RESOLUTION SETTING HEARING ON REQUEST FROM QUIK TRIP CORPORATION (OWNER/LESSEE), REPRESENTED BY MATT BROOKS (OFFICER), TO REZONE PROPERTY LOCATED AT 2428 AND 2426 HUBBELL AVENUE AND 2401 EASTON BOULEVARD FROM "C-1" NEIGHBORHOOD RETAIL COMMERCIAL DISTRICT, LIMITED "M-1" LIGHT INDUSTRIAL DISTRICT AND "M-1" LIGHT INDUSTRIAL DISTRICT TO LIMITED "C-2" GENERAL RETAIL AND HIGHWAY ORIENTED COMMERCIAL DISTRICT

September 16, 2014

STAFF REPORT TO THE PLANNING COMMISSION

Quik Trip Corporation, 2428 Hubbell Avenue

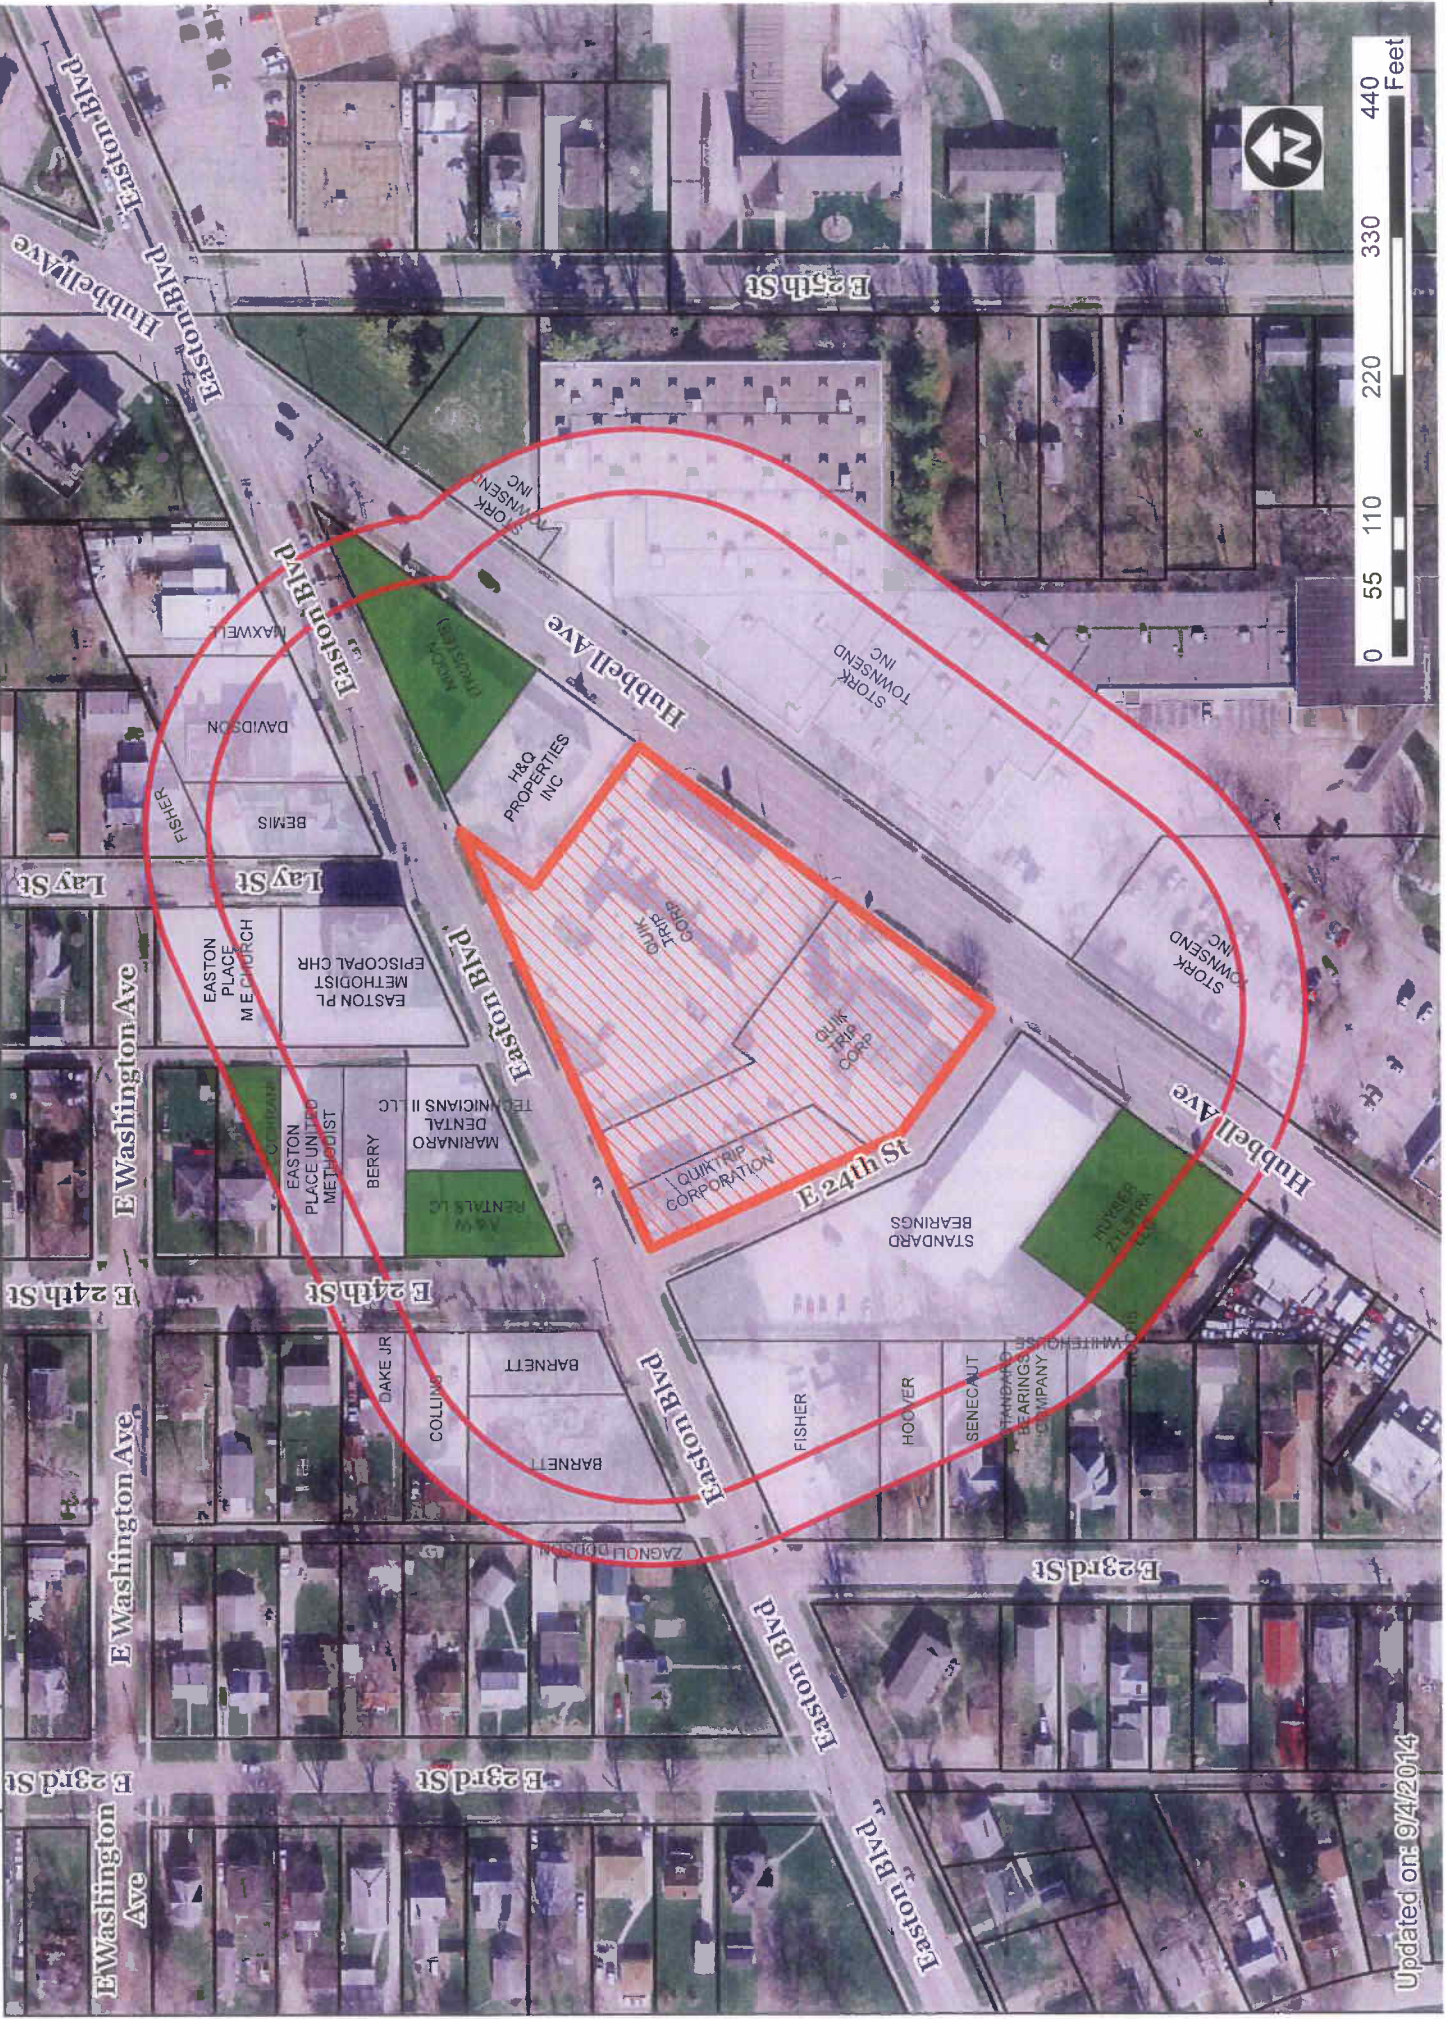
The proposed trash enclosure would be constructed of masonry material with polymer mesh opaque gates. Staff recommends that the gates be revised to be solid metal gates.

The applicant is proposing to wrap canopy columns in brick to match the principal building. Sheet C110 indicates that the bottom of the canopy would be 15 feet above grade at its lowest point, which is needed to accommodate fueling truck

clearance. The overall canopy height would vary from 18.5 feet to 19.87 feet. Staff believes the proposed canopy generally meets the intent of this guideline, as the variation in height is due to a change in grade on the site.
